41 Marine Parade, Avalon

Response to Stability Assessment

The purpose of this correspondence is to respond to the JK Geotechnics Geotechnical Stability Assessment (the JK Report) dated 15th August 2016.

SITE PLAN – showing test locations

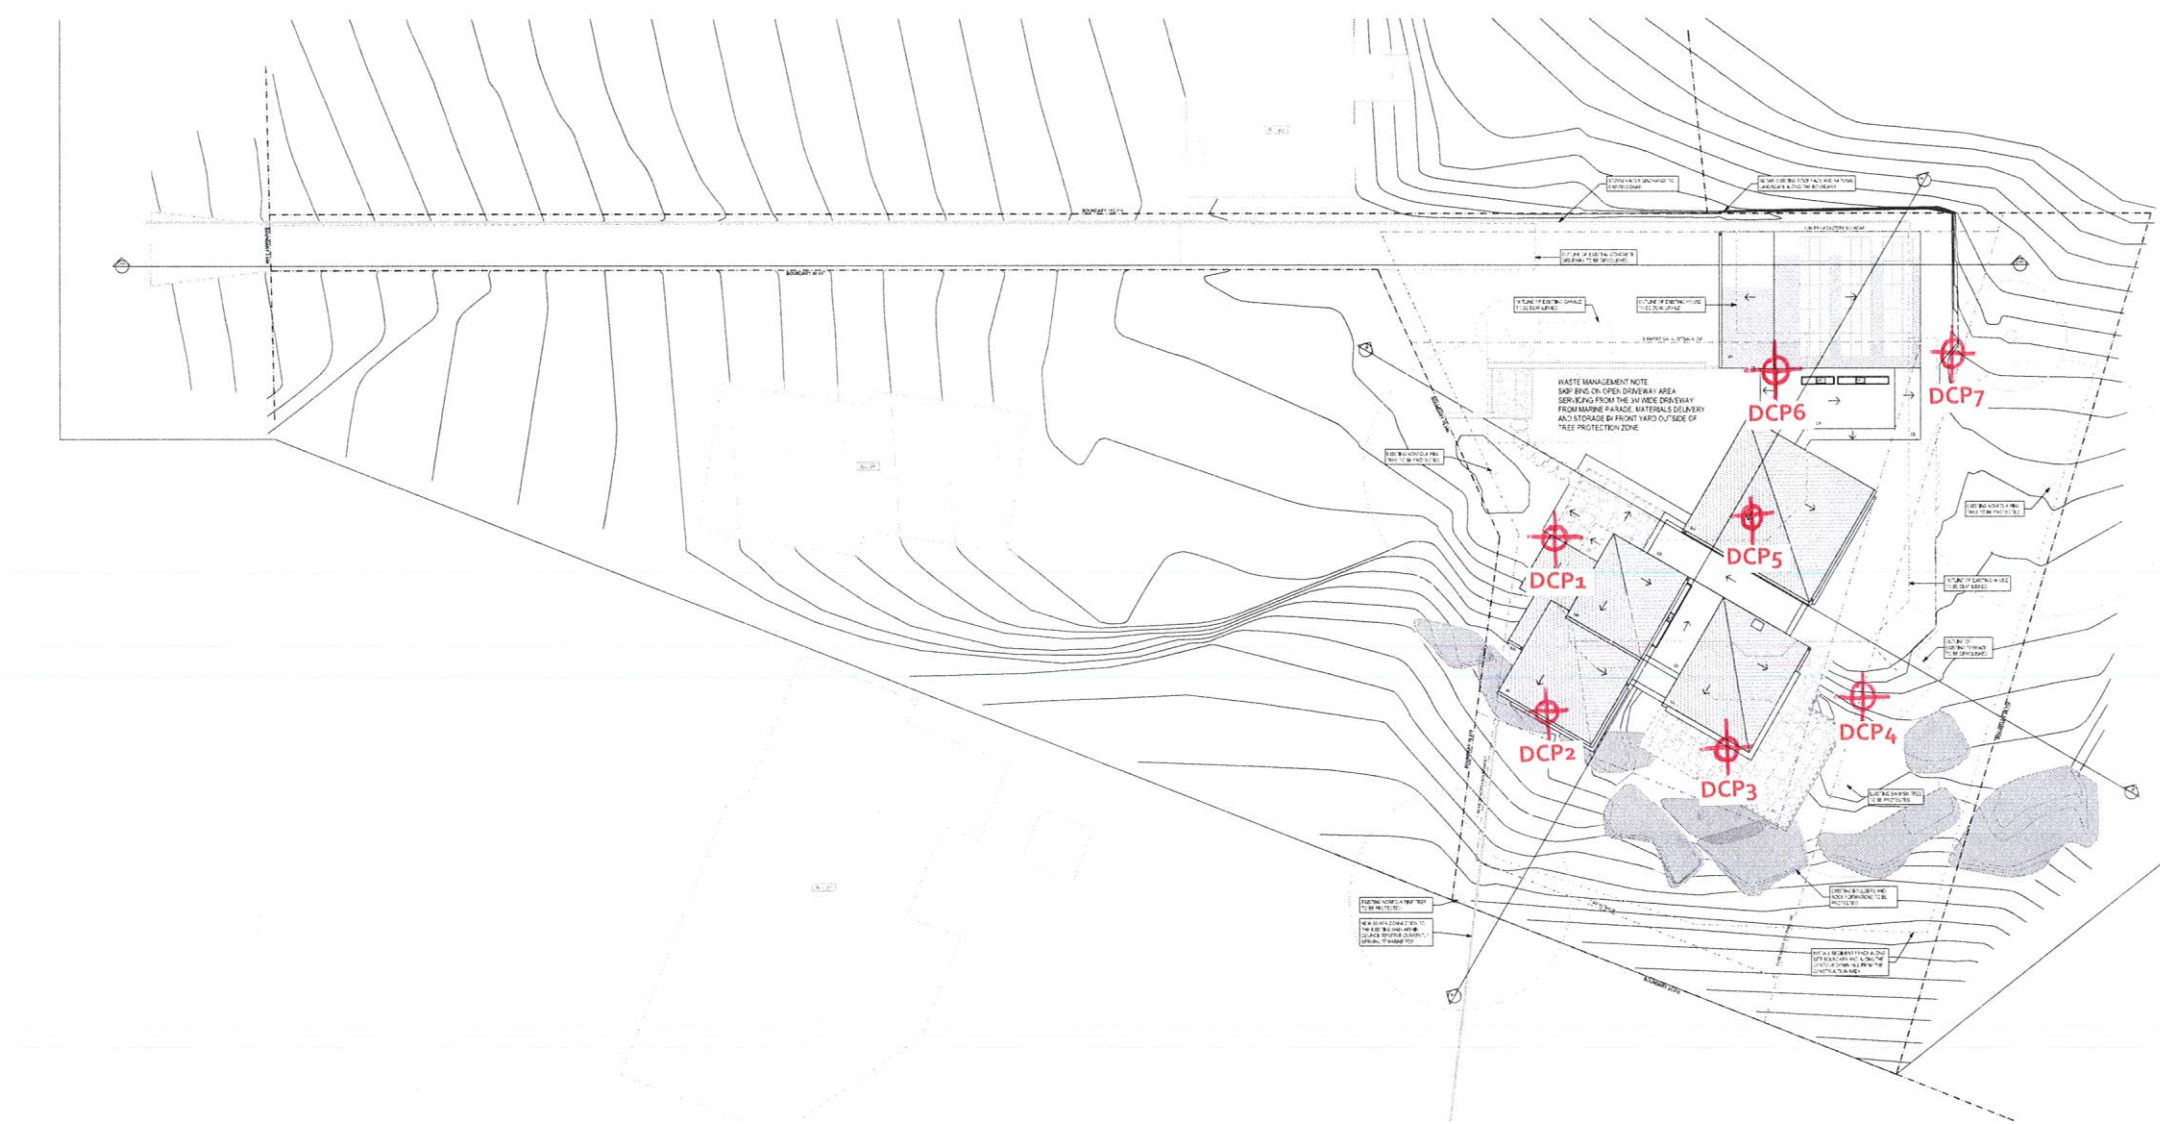
"Mapping details have not been presented on a contoured site plan"

"Basix Certificate 3A (Drawing A1.1) states "Existing boulders and rock formations to be protected" on western side of site. Also, Section A on Drawing A2.3 shows existing ground line at lower level dotted, but no 'floaters'. We consider that such protection will not be feasible."

1. The mapping details were presented on a contoured site plan. In the scanning the plan the light grey contours were not picked up by the scanner though the surveyed boulder locations below the house were. A darker copy of that plan is attached.

6. Further to my related responses to the on-going stability of the outcropping joint blocks on the western side of the development I also note that architectural Plan A1.4 confirms that the large joint blocks immediately below the house will be retained as part of the development.

SITE PLAN – showing test locations

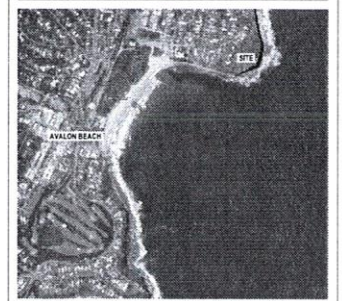
"Mapping details have not been presented on a contoured site plan"

"Basix Certificate 3A (Drawing A1.1) states "Existing boulders and rock formations to be protected" on western side of site. Also, Section A on Drawing A2.3 shows existing ground line at lower level dotted, but no 'floaters'. We consider that such protection will not be feasible."

1. The mapping details were presented on a contoured site plan. In the scanning the plan the light grey contours were not picked up by the scanner though the surveyed boulder locations below the house were. A darker copy of that plan is attached.

6. Further to my related responses to the on-going stability of the outcropping joint blocks on the western side of the development I also note that architectural Plan A1.4 confirms that the large joint blocks immediately below the house will be retained as part of the development.
